# Quality Control Report

**Consultant** **Wahib Medanat** Consultant Engineers  
**Site Name** Hay Al Iskan Basic mixed - Jerash  
**Package** Package 2  
**Contractor** Dijlah Est. Construction Co.  
**Tender No.** 10/2019/USAID/SKEP/3/2

**Rep No.** QC-21 22  
**Date** 17 / 07 / 2022

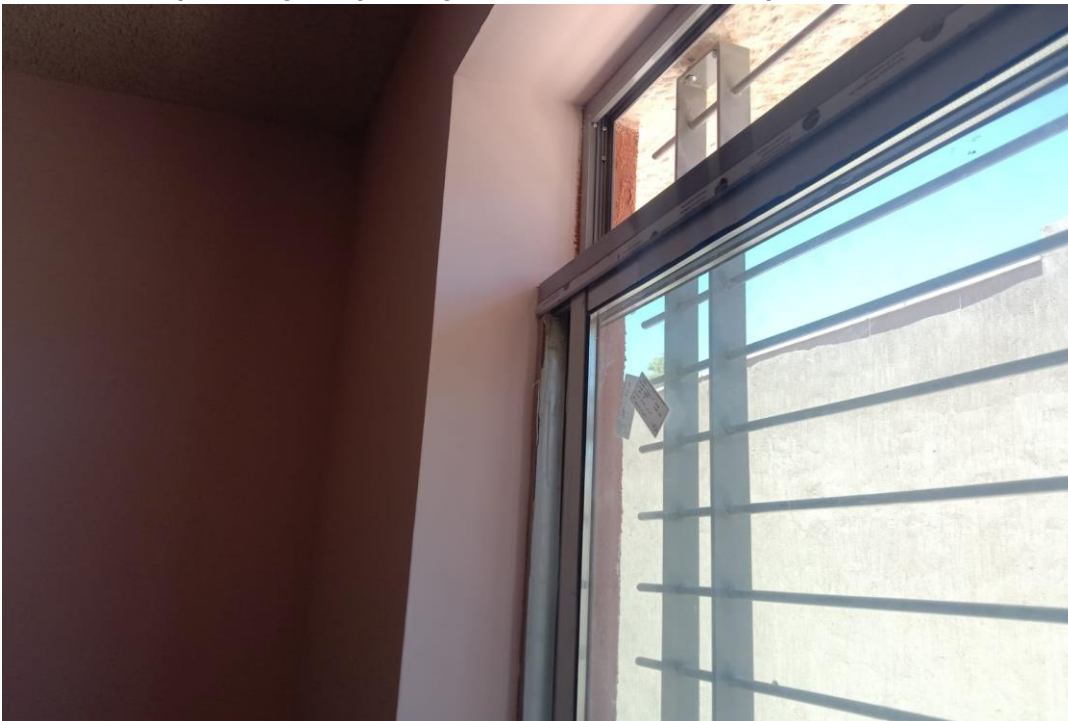
**Waviness in the painting of the suspended ceilings**

**Fixation of the handrails of the staircase is insufficient**
